NOTICE OF DECISION

CLASS 3 SITE PLAN REVIEW / CLASS 1 DESIGN REVIEW NO.: SPR-DR17-16

SUMMARY: Proposed development of a 96-unit apartment complex.

**SITE PLAN REVIEW / DESIGN REVIEW
CASE NO. SPR-DR17-16
DECISION**

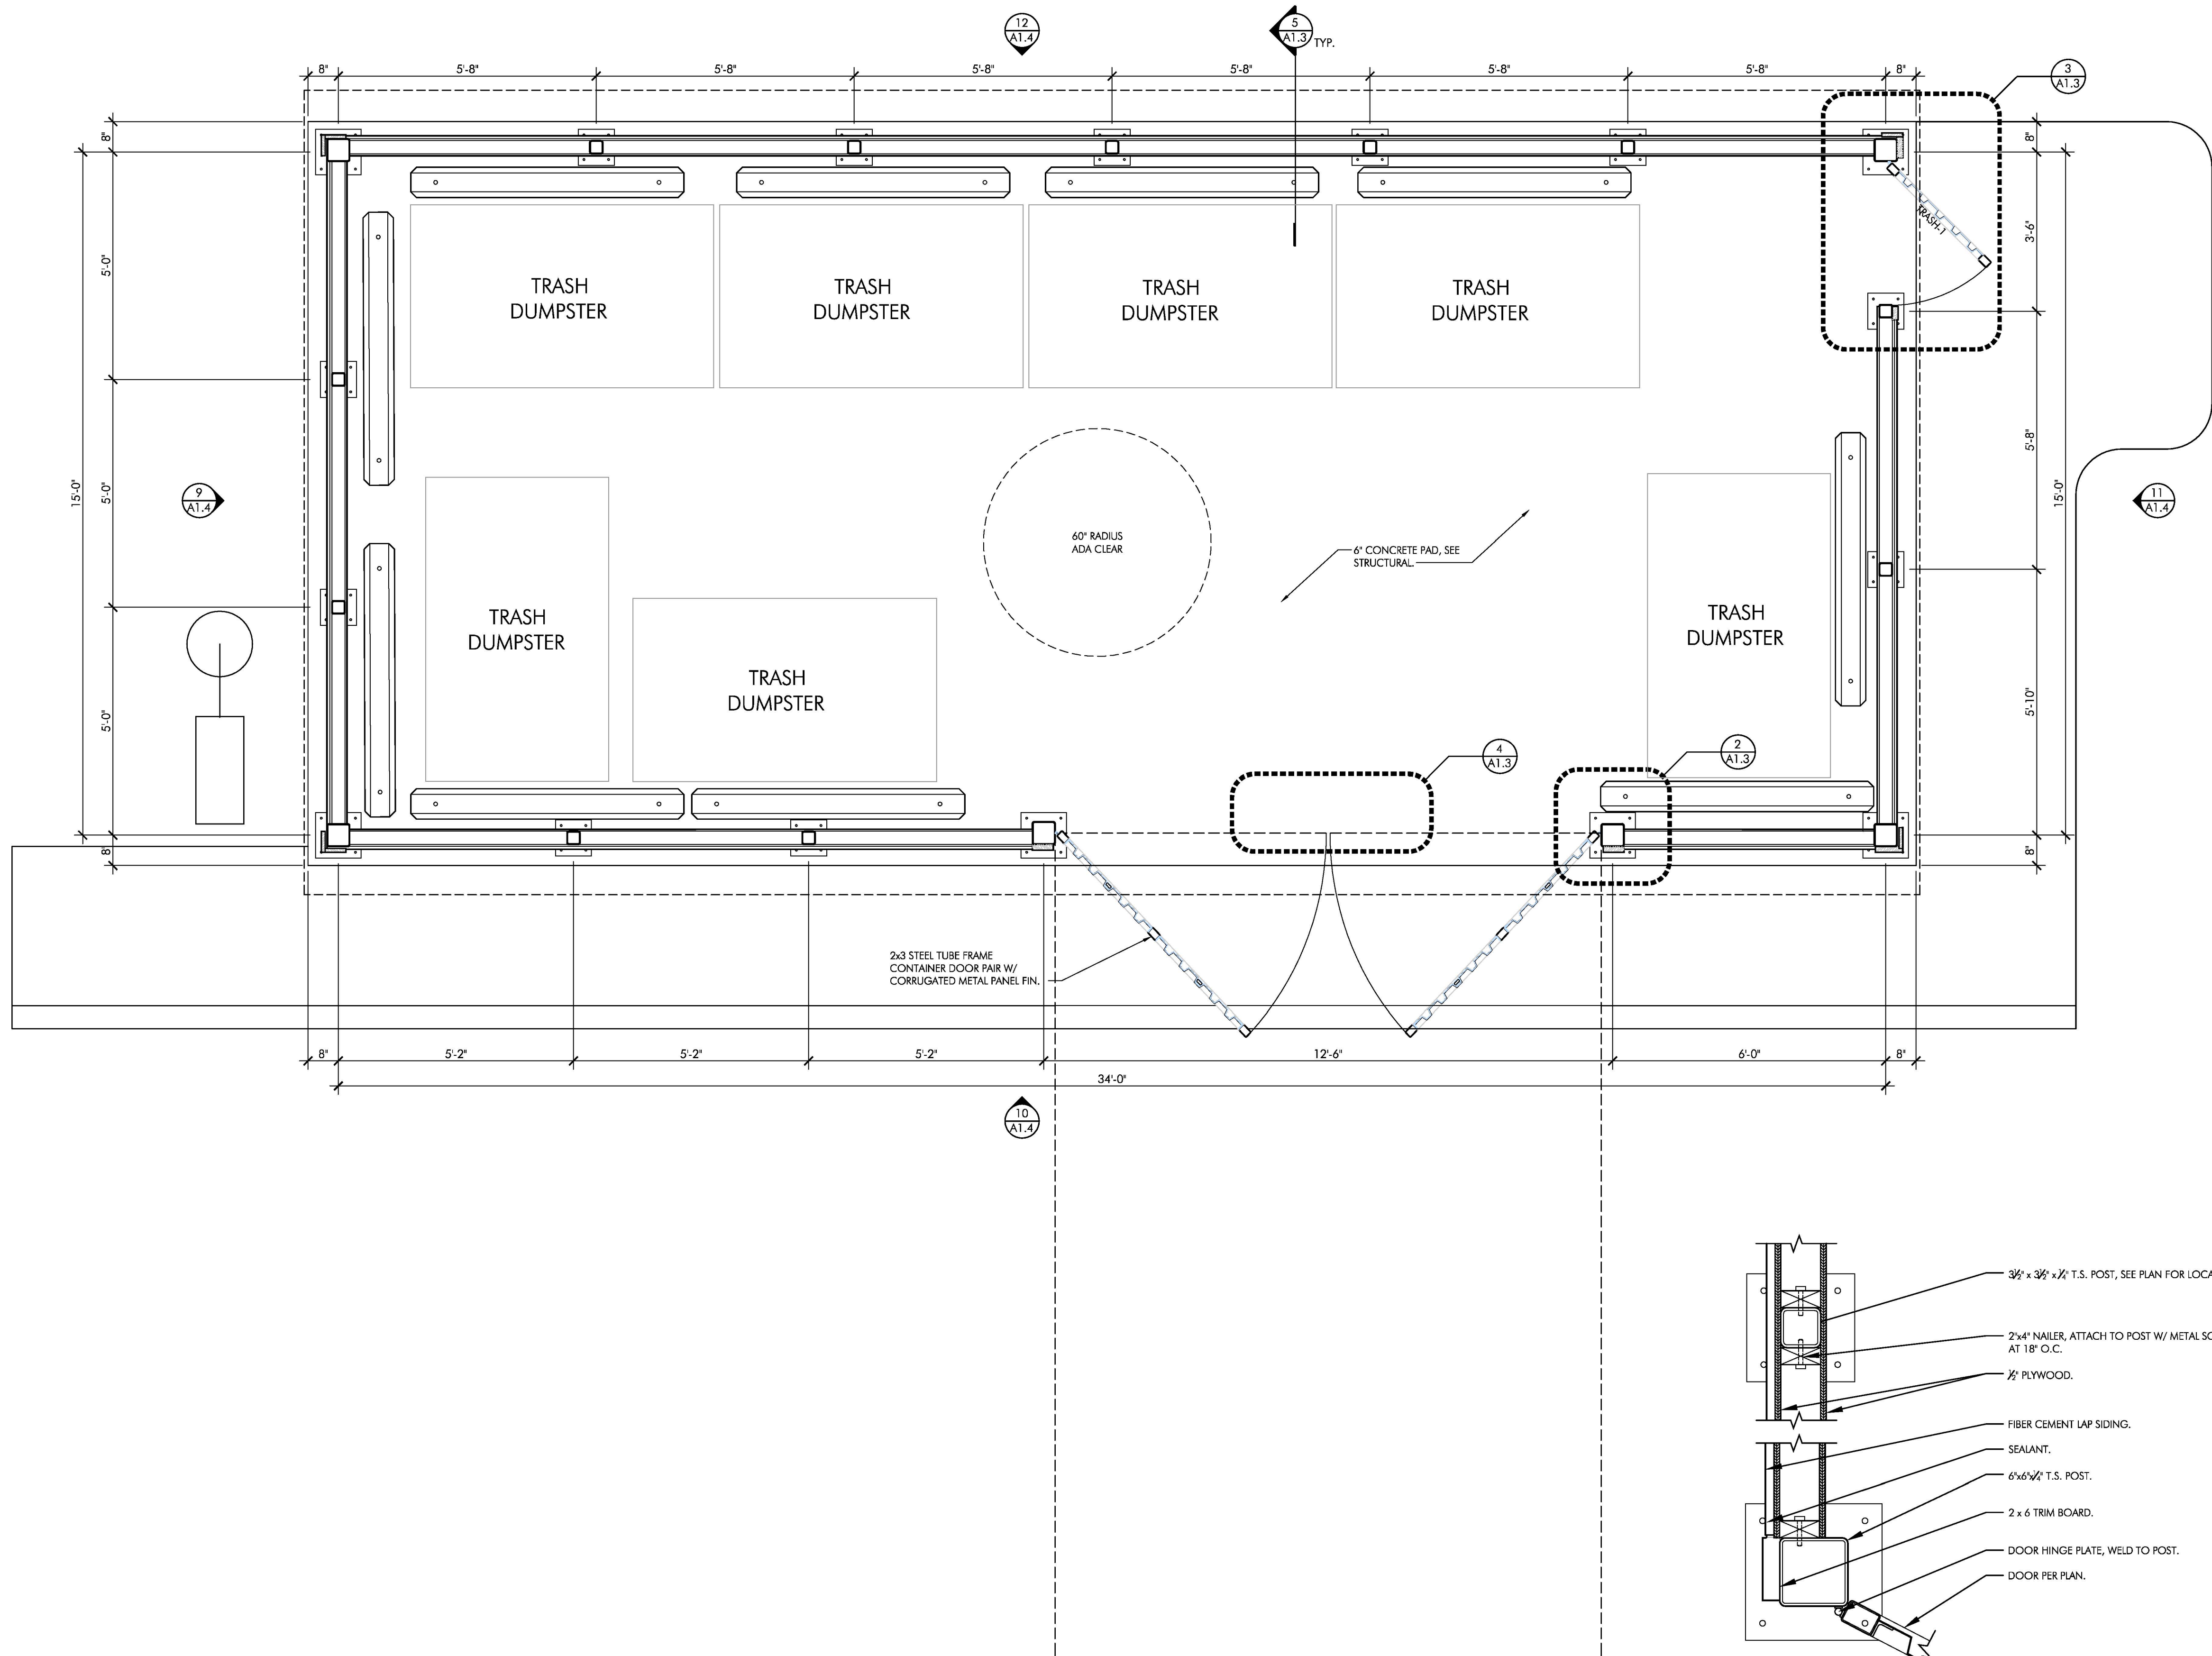
Staff Response: Oxford Street SE is not designated in the Salem Transportation System Plan and is improved as a public alley. No vehicular access is proposed to Oxford Street SE. The proposed site plan indicates that a new 6' tall site obscuring wood fence will be provided along the full extent of the southern boundary, separating the proposed multi-family use from Oxford Street SE.

Finding: The proposed multi-family use includes 96 dwelling units, requiring a minimum of 10 bicycle parking spaces ($96 \times 0.1 = 9.6$). The proposed site plan indicates that there are approximately 44 bicycle parking spaces provide throughout the site, exceeding the minimum requirement.

Finding: The site plan indicates that a fence will be provided around the children's play areas.

Finding: The proposed development utilizes an existing driveway on 23rd Street SE which will provide shared access for the proposed apartments and the existing retail commercial building. Unused existing driveways on 23rd Street SE are required to be removed.

Condition 2: The existing unused driveway approaches to 23rd Street SE shall be removed and replaced with new curb and sidewalk.

Condition 2: The existing unused driveway approaches to 23rd Street SE shall be removed and replaced with new curb and sidewalk.

1 TRASH ENCLOSURE PLAN
0' 1' 2' 4' 6' 1 1/2" = 1'-0"

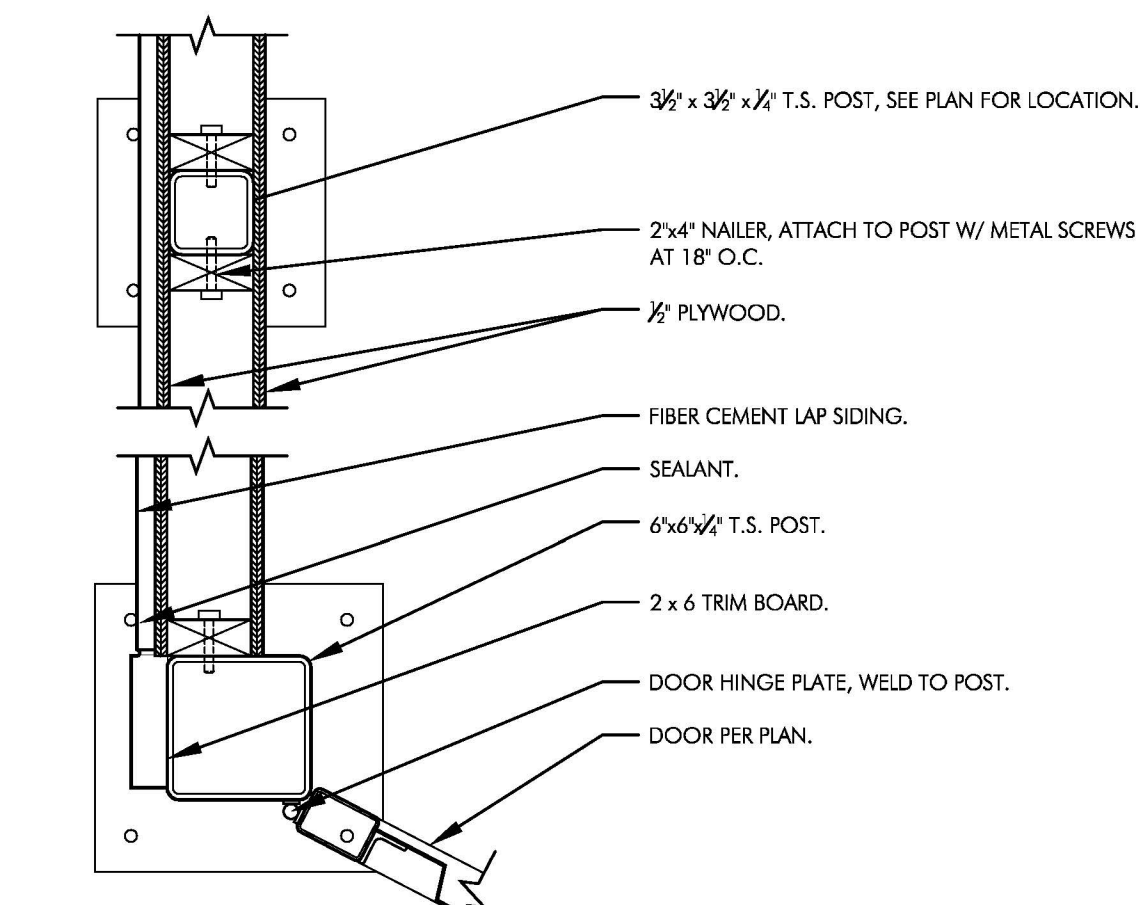
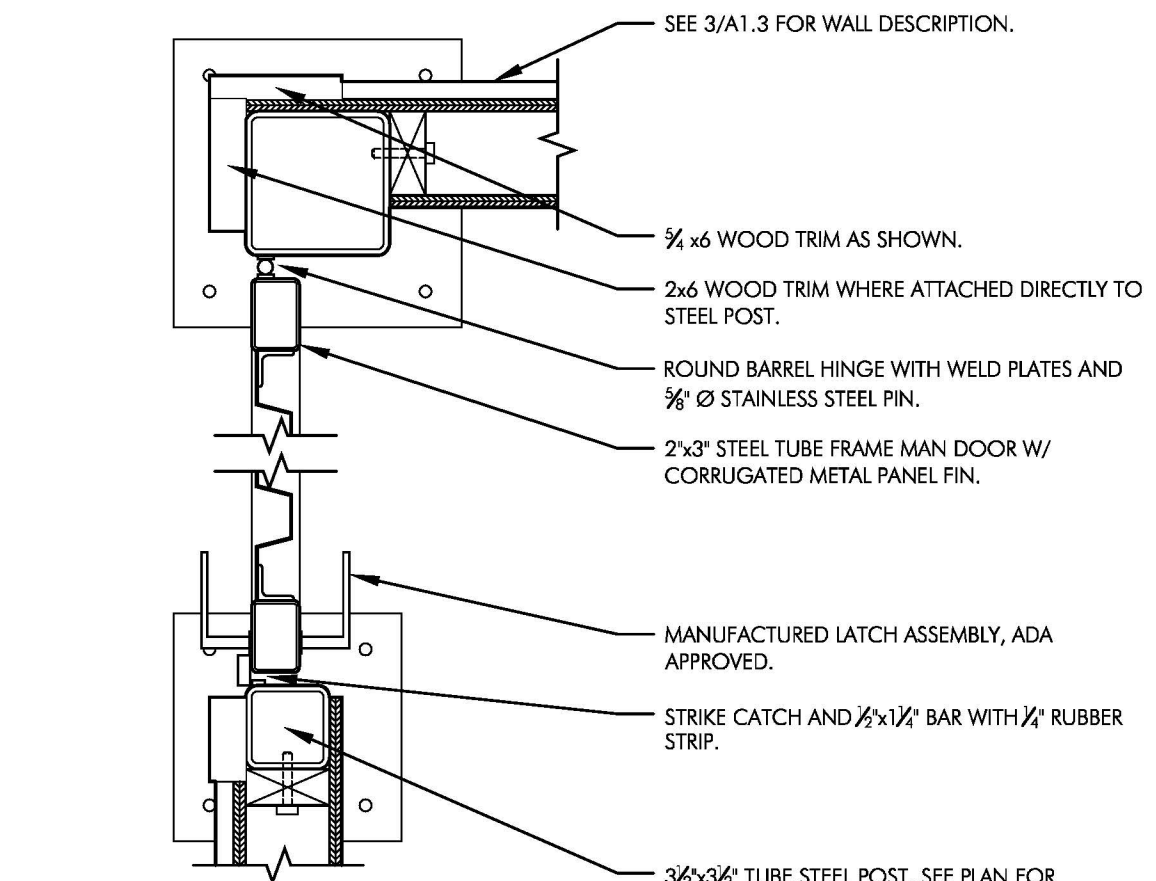
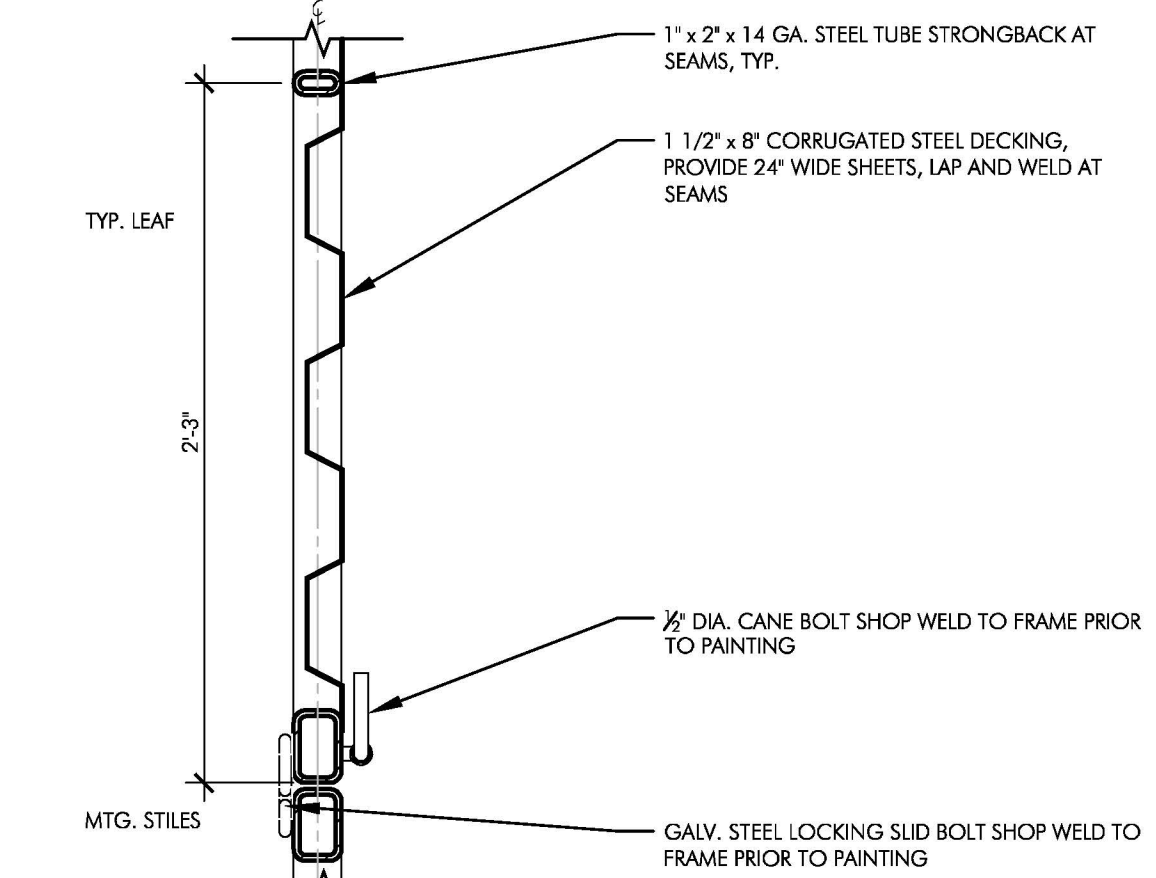
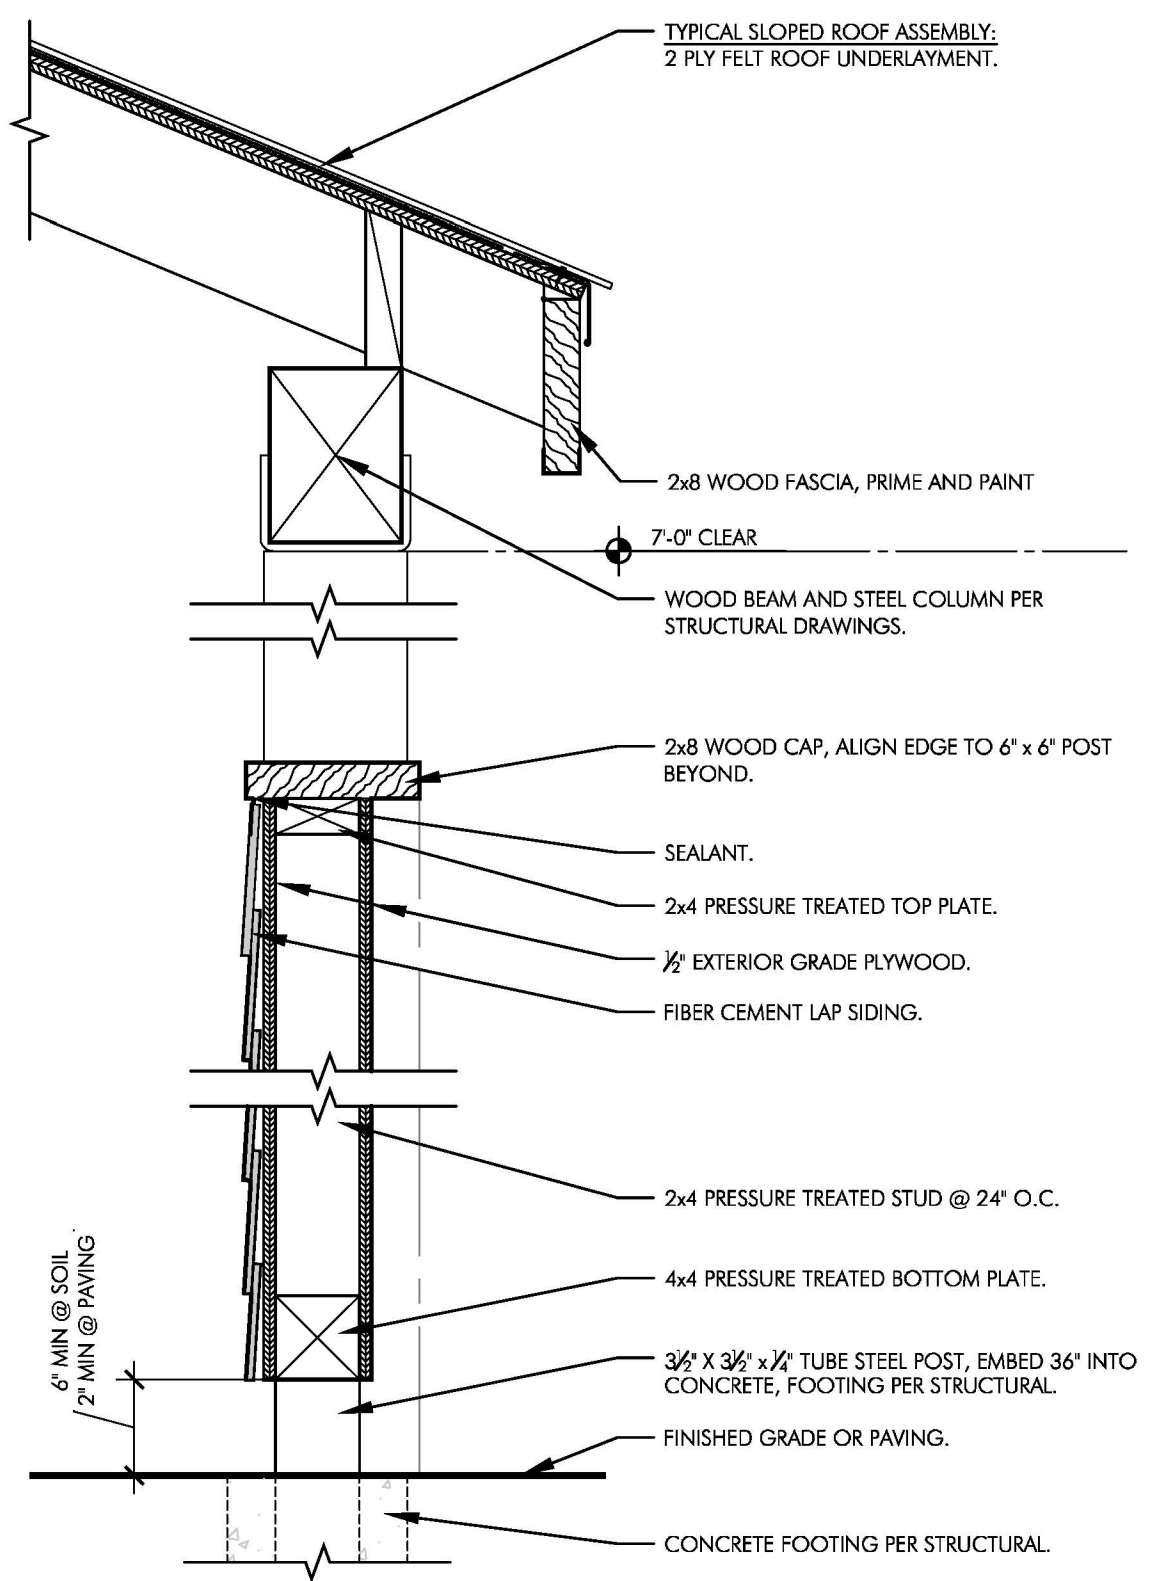
Finding: A partial roof is provided over the trash and recycle areas to provide weather protection for the recycling areas.

Finding: The plans indicate that the trash enclosures will have a wood construction with lap siding and roofing to match the proposed buildings.
